Economic and Social Council

Proposal for the 01 series of amendments to Regulation No. 119 (Cornering lamps)

Submitted by the Working Party on Lighting and Light-Signalling (GRE)*

Figure 1
Marking for single lamps

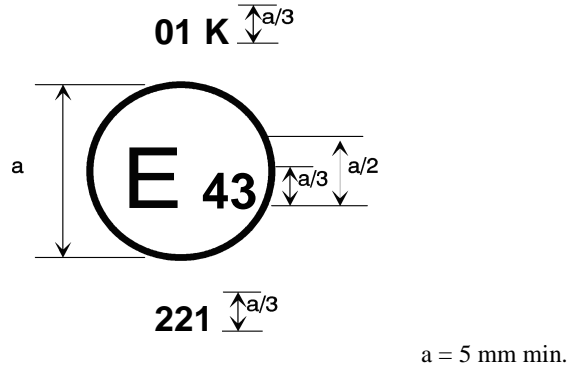
Annex 2, Figure 1 and the text, amend to read:

The device bearing the approval mark shown above is a cornering lamp approved in Japan (E 43) pursuant to Regulation No. 119 under approval number 221. The approval number indicates that the approval was granted in accordance with the requirements of Regulation No. 119 as amended by the 01 series of amendments.

“Figure 2

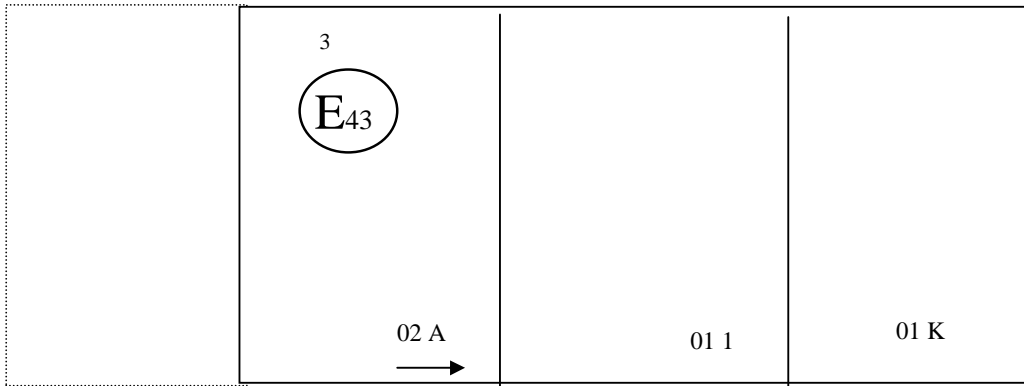
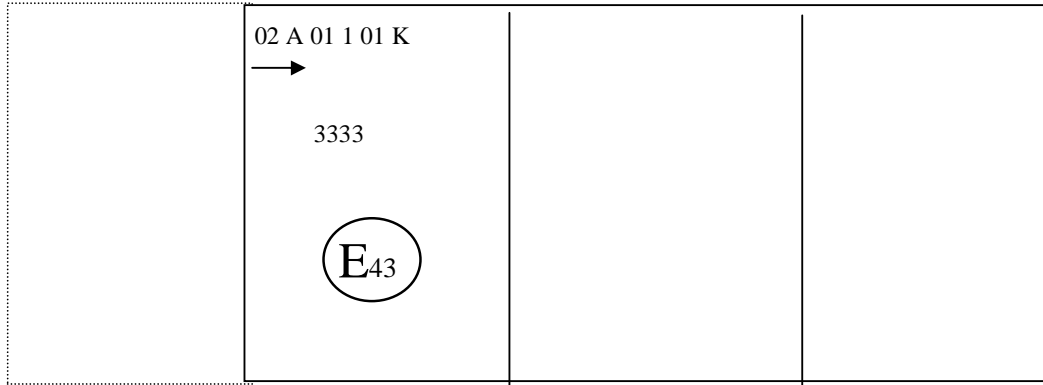
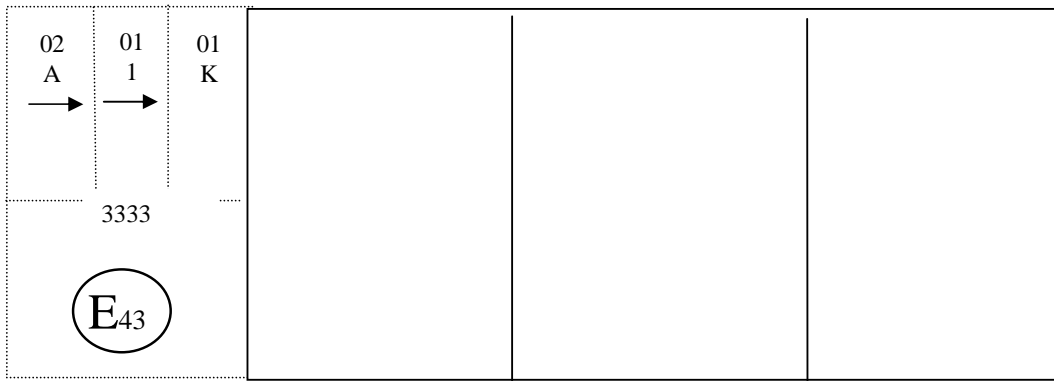
Figure 2 and the text, amend to read:

A cornering lamp approved in accordance with the 01 series of amendments to Regulation No. 119.”
